2. Item: **Variance #14-05** (Reso. #15-02)

Request: Variance of 10 feet to the maximum 35 feet height for
an architectural roof monitor feature on the proposed
Iditarod Elementary School.

STAFF REPORT

Case #: U14-04
Prepared by: Planning Staff
Meeting Date: January 20, 2015
(Rescheduled from 1/13/15)

SHEET NO. **C211**

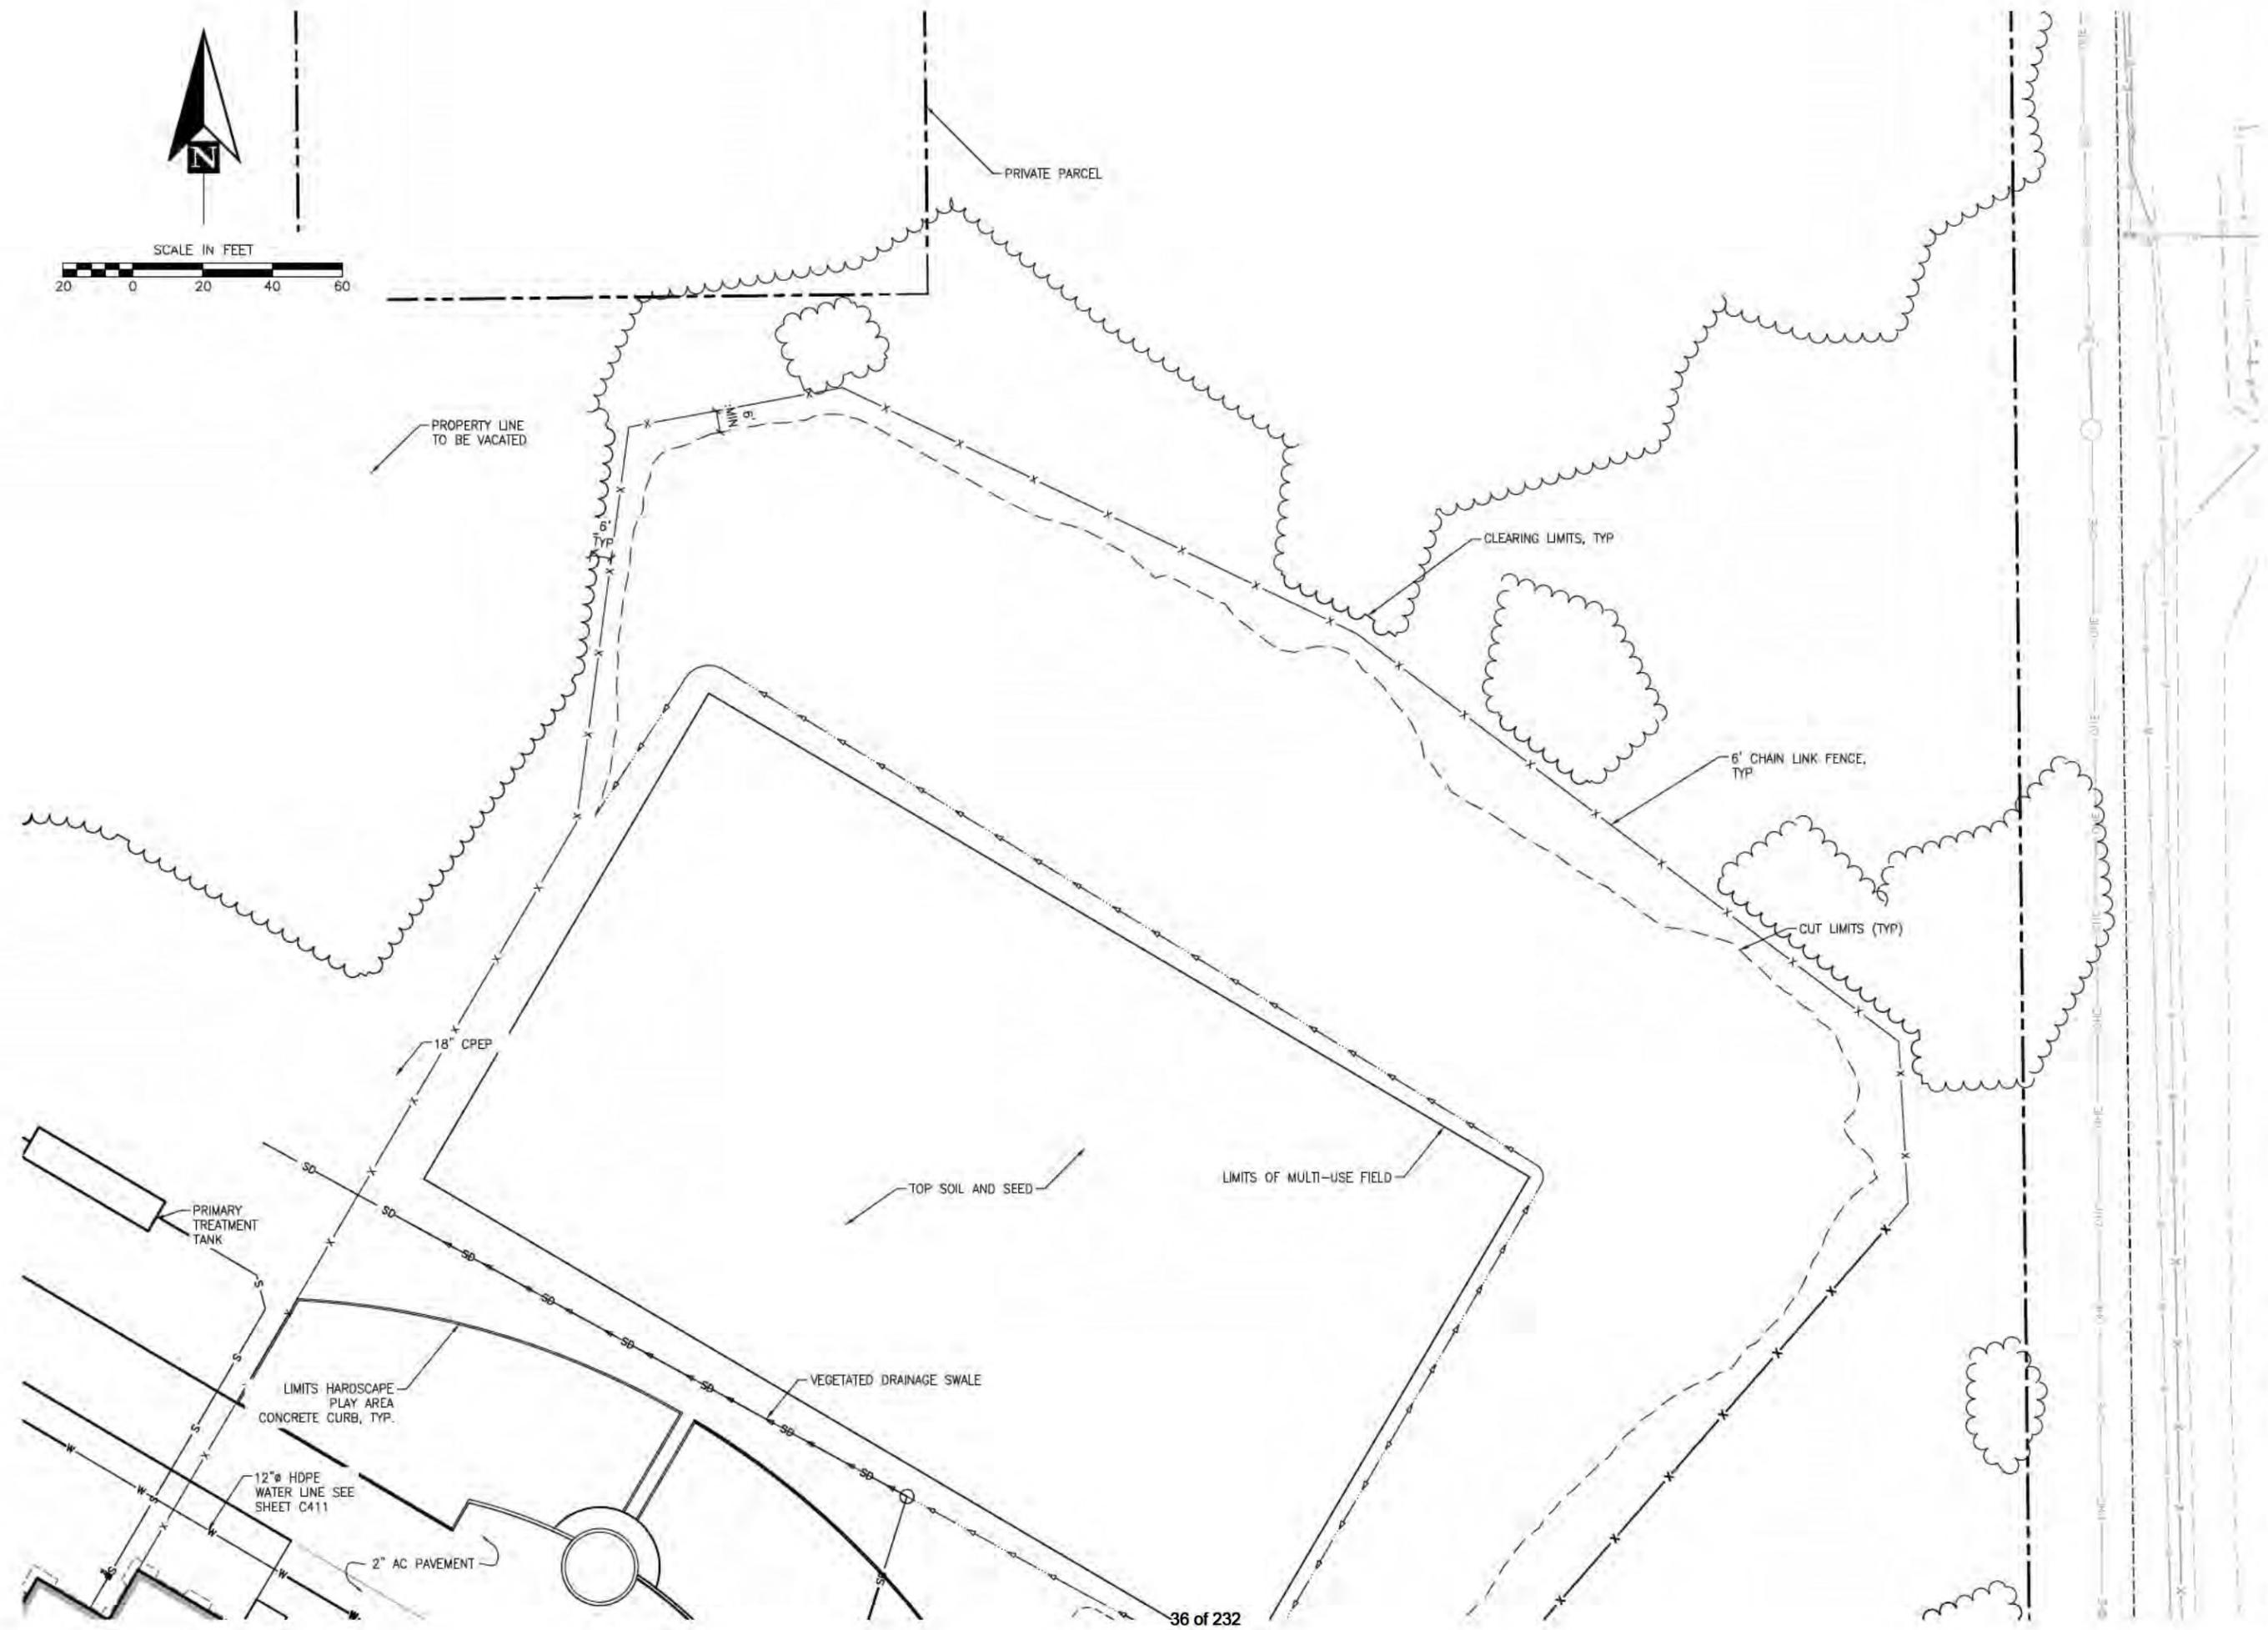
The site plan proposes four access points – three on E. Carpenter Circle and one “exit only” on Wasilla-Fishhook Road.

Staff is recommending that the Planning Commission add two conditions to the use permit approval. The first condition would limit the new elementary school to two access points onto E. Carpenter Circle. The second condition is that the proposed sidewalk be extended to the eastern property line along the north side of E. Carpenter. This sidewalk extension will provide connectivity between the new elementary school and Wasilla High School and it will provide a safe area for the neighbors to walk in the neighborhood and to shopping areas.

Staff is recommending that the Planning Commission add two conditions. The first would be to limit the new elementary school to two access points – one for the bus area and one for the drop-off/pick-up loop and parking areas. This redesign will minimize the number of vehicle trips along E. Carpenter Circle since vehicles would have the choice to exit directly onto Wasilla-Fishhook Road instead of utilizing E. Carpenter Circle as an exit. The second condition would be to require extension of the proposed sidewalk to the eastern property boundary. This would provide a safe walking area for residents in the area and also provide pedestrian connectivity from Wasilla-Fishhook Road to Wasilla High School.

Although the use permit and variance of this case has merit, we would like to address the use of E. Carpenter Circle, as a thoroughfare for the school buses running back and forth on our street, which by two lane road standards, is probably questionable. Another concern is the MAT-SU Boroughs current plot plan of the proposed school, with its entrances and exits. As depicted in their plan, it will be impossible for parents to drop off students, and buses to exit the only way back to Fish Hook Road. At certain times of the day the residents on E. Carpenter Circle will be hampered by the congestion caused by the increased amount of traffic on our street thereby causing the residents to alter there plans. Basically, E. Carpenter Circle is a dead-end street. Safety can be an issue, when the intersection of E. Carpenter Circle and Fish Hook Road is congested to the point of 'grid-lock'.

A solution to this problem would be for the planners to just rotate the proposed plan 90 degrees clockwise. In other words, the entrances that appear on E. Carpenter Circle, would be on Fish Hook Road, allowing for entrance and exit from the school property, and protecting the residents on E. Carpenter Circle, similar to how the existing school is configured. There appears to be enough land to accommodate that idea.

As a homeowner living on E. Carpenter Cr. In Wasilla, I naturally have a personal interest in how the construction and operation of the new Iditarod ES will affect me. I also have another perspective by which to evaluate the plan. For the last 8 years I have been a school bus driver in the Mat-Su School District. Prior to that I drove school bus for 5 years in the Anchorage District. Over the years I have driven to every school in the Mat-Su. and I can tell you that it makes a huge difference in how the traffic flows into and away from a school. Many parents choose to drop-off and pick-up their children from school rather than ride the bus. Any school with totally separate bus and pov traffic patterns operates much more safely and efficiently. A good example of a bad situation is nearby Wasilla Middle School. All one has to do is spend about 30 minutes one afternoon around school dismissal time to see the chaos of students going every direction and parents and buses jockeying for position. This is especially true for the special needs buses that park along side of the gym. It is not only chaotic, but is unsafe for the students. By contrast, the situation at the newer Machetanz es is the total opposite. Not only are there totally separate drop-off areas for buses and pov's, but they each have their own driveways onto and away from school property.

For these reasons, I strongly recommend that the site plan for the new Iditarod es include a second access from Wasilla-Fishhook Rd.

1. Only two access points may be constructed onto E. Carpenter Circle – one for the bus only area and one combined access for the drop-off/pick-up and parking area. Any additional driveways must utilize Wasilla-Fishhook Road. An updated site plan showing the revised driveway locations must be submitted to the Planning Department and Public Works Department for review and approval prior to beginning construction on the site.
2. The sidewalk along the north side of E. Carpenters Circle must be extended to the eastern property line of the subject property.

In addition to separate access points, the design team also reviewed multiple iterations of driveway locations. The proposed site plan was deemed the safest option, providing the clearest traffic patterns for motorists. In other iterations with a single use driveway off of Wasilla-Fishhook, be it bus operations, student drop-off, or parent/faculty parking, the likelihood of a motorist entering what appears to be a main entrance was high, resulting in cross-use tendencies, i.e. passenger vehicles in the bus loop, student drop-off in the parking lot, or drive-through vehicles in the drop-off loop. These conditions were deemed unsafe to children and motorists.

With a lower speed, and lighter traffic volume the proposed plan provides clearer delineation of traffic patterns. Additionally, with the bus and maintenance access at the far end of Carpenter Circle, it limits parent traffic to the first 800 feet of Carpenter Circle, with only buses, five at most, traveling to the end of the street. As for traffic impacts to the residents along Carpenter Circle, PND visited the existing Iditarod Elementary School on October 29, 2014 to observe traffic patterns and volume during the morning drop-off period. The morning period was determined to be the controlling time
